Origination Form
Proposed Revisions to a Standard Plans Index

Originator:	Stepp, Richard	Index Number:	715-001
Date:	6/30/2026	Sheet Number(s):	1
E-mail:	richard.stepp@dot.state.fl.us	Index Title:	Conventional Lighting

METAL POLE DETAIL

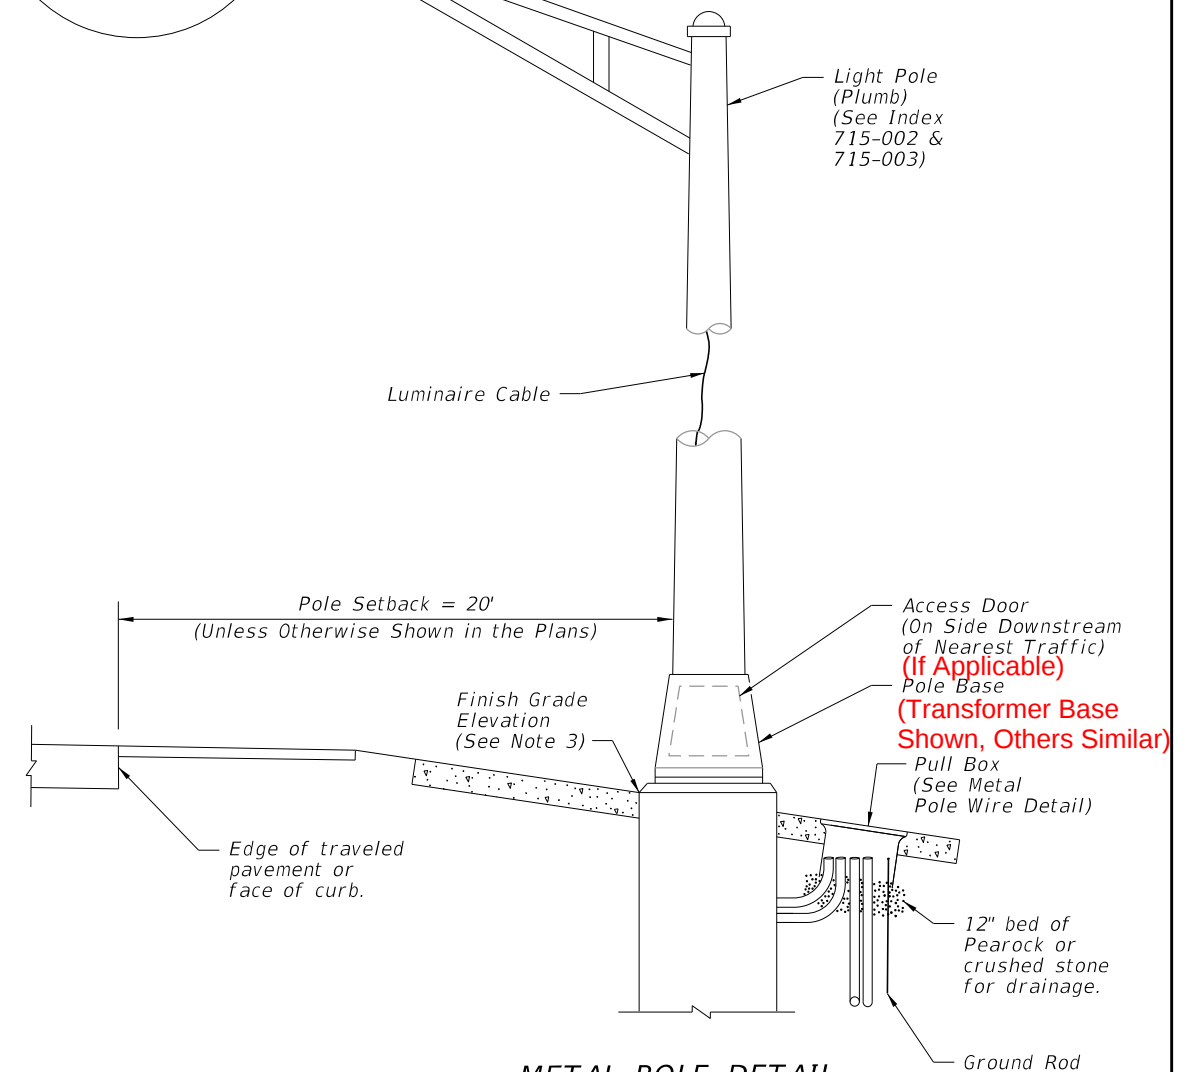
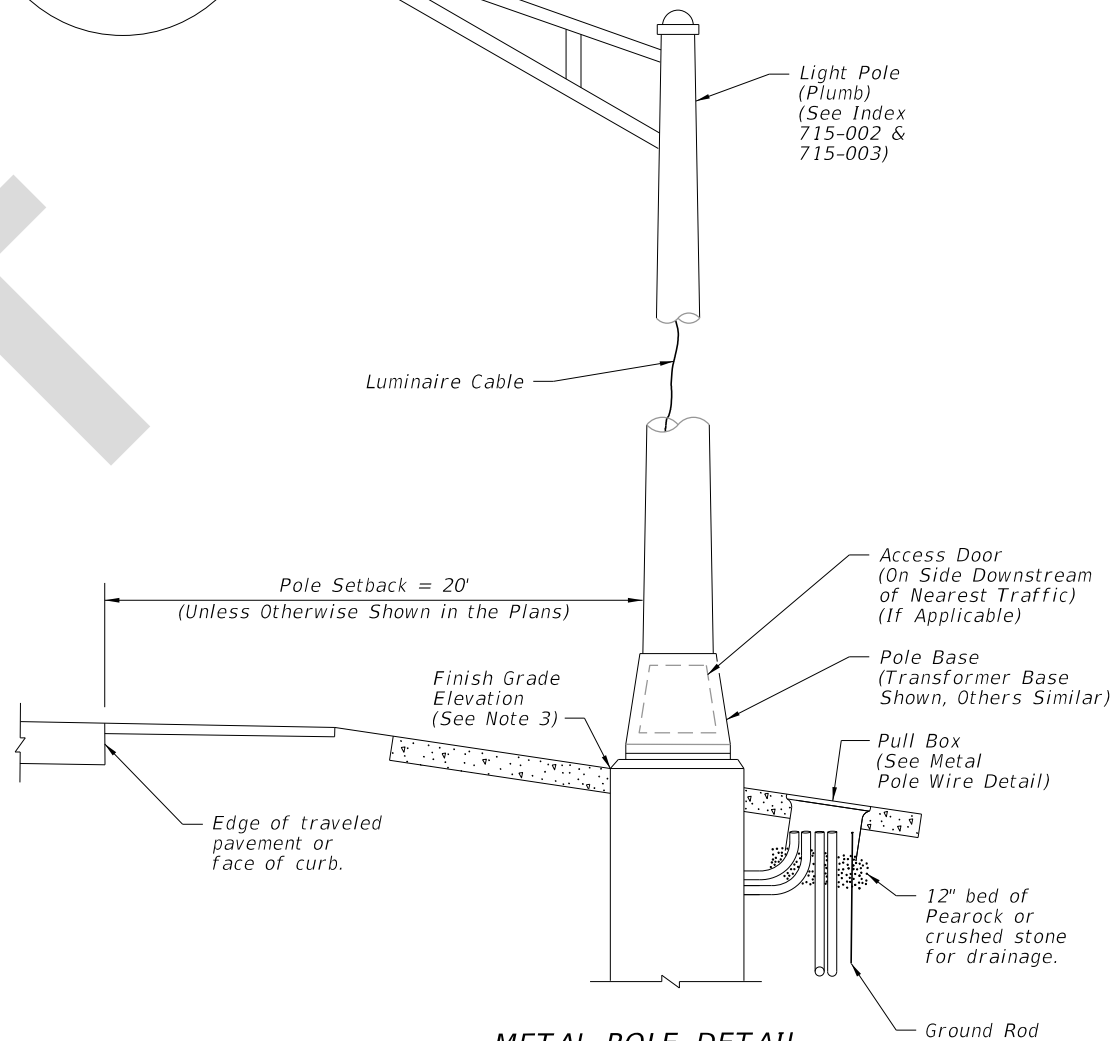
Sheet 1: Added "(Transformer Base Shown, Others Similar)" to the Pole Base callouts in the elevation details; Added "(If Applicable)" to the Access Door callout.

Revisions were made to support additional light pole base options as shown on the APL. For example, in addition to the transformer base option shown in the Index, the breakaway bolt option on the APL may be used instead. Having more light pole base options helps to alleviate supply chain restrictions, which may help improve construction schedules. Additionally, this revision helps to streamline the process by providing options that are pre-approved for BABA. This revision is being made in conjunction with others in Index 715-002, 715-003, and Standard Specifications 992.
